**PREVOST**

**SAFETY  
RECALL**

**SR22-13**

| SUBJECT: | DRIVER SEAT REPLACEMENT WITH RECARO 3-POINT BELT DRIVER SEAT |                  |

Figure 5

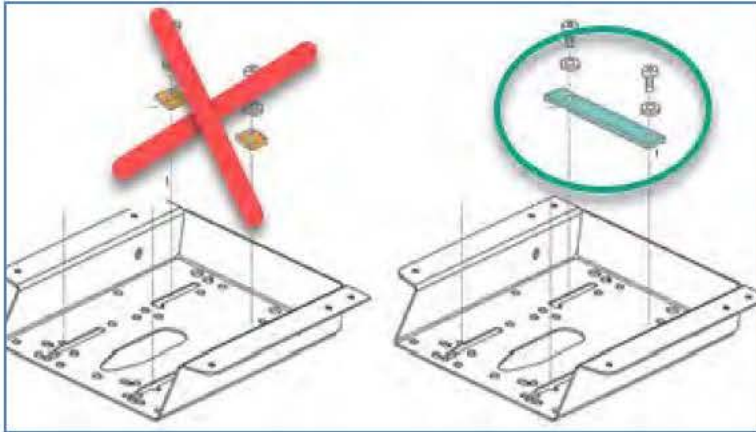
8. Replace the 2 backplates securing the riser with the long bar supplied with the new seat.

***Torque to 38 lb-ft***

***apply torque seal marks***

Figure 7

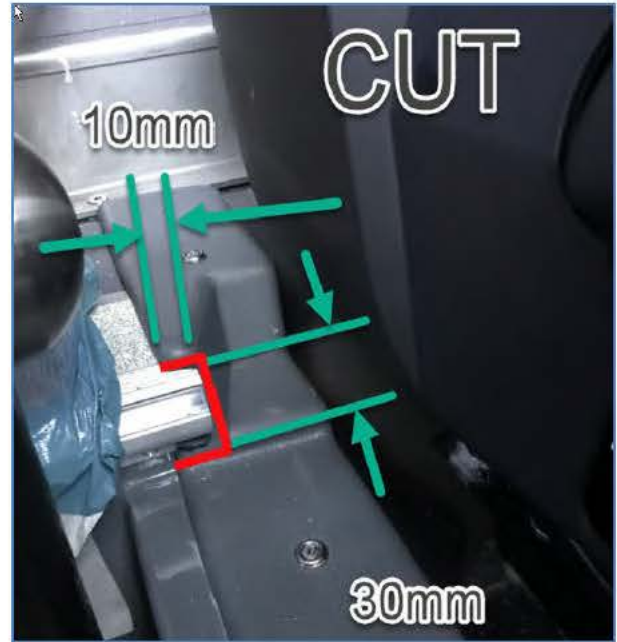
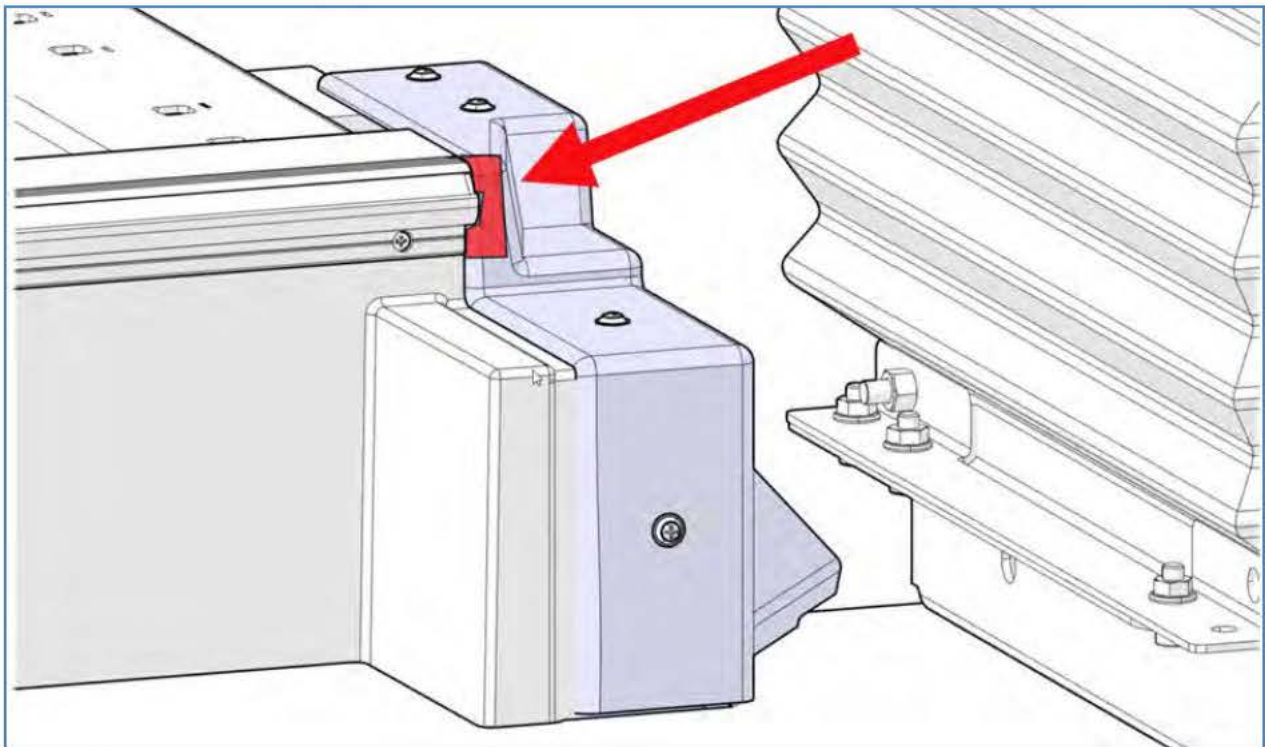
9. Remove the aisle stairs cover and cut a part of it as shown.

Dimensions to cut: about 10 mm X 30 mm

Figure 9

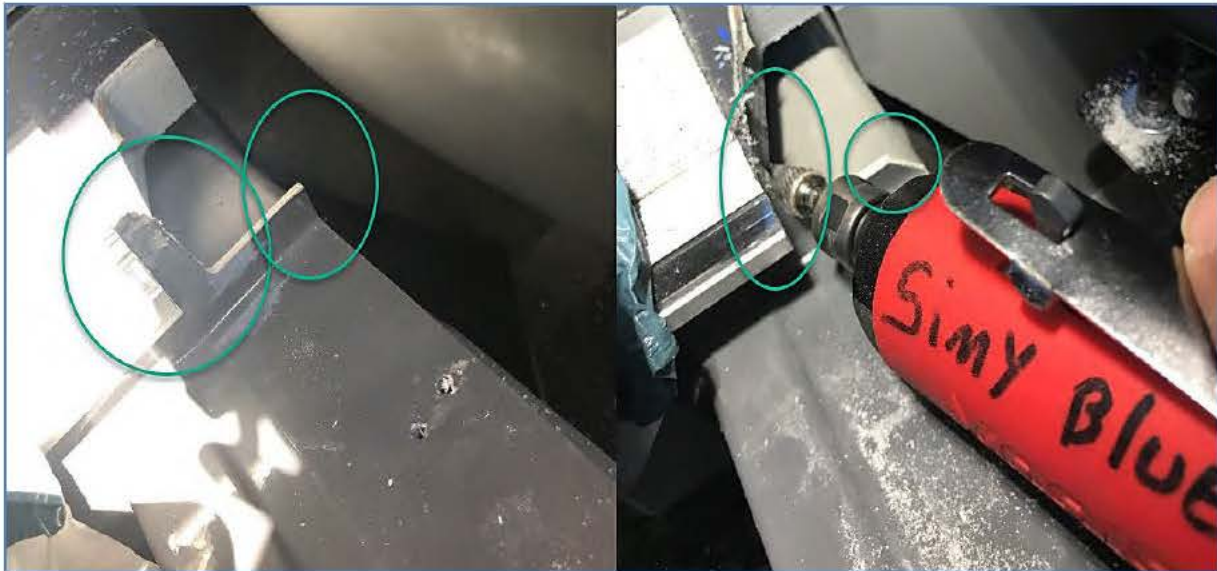
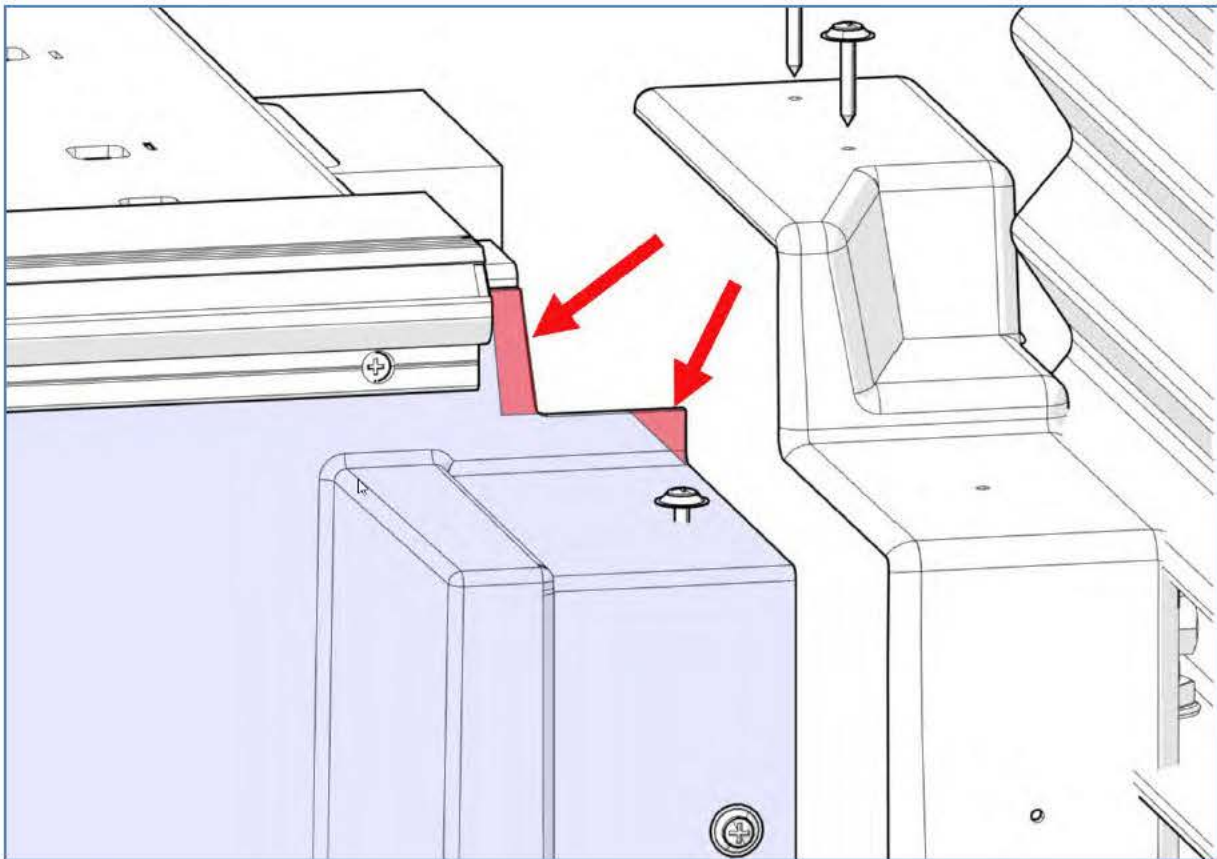
10. Cut fiberglass on the stairs as shown. The goal is to reinstall the cover as far as possible towards the entrance door so to leave a greater clearance between the seat and the cover.

Figure 14

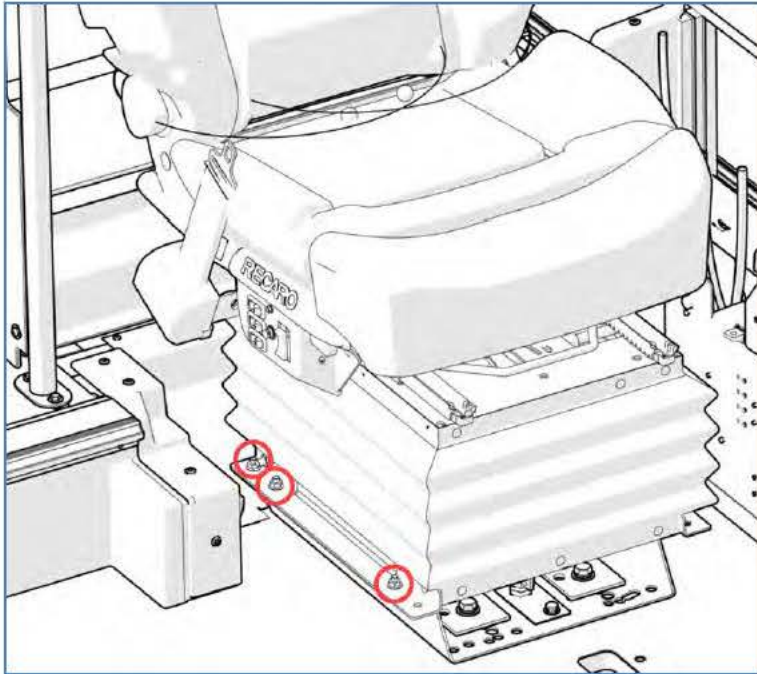
14. With the help of an assistant, install the new seat on the riser with the 6 screws previously removed. For aesthetic consideration, apply torque seal marks only if torque seal marks were present on the previous installation.

***Torque to 16.5 lb-ft***
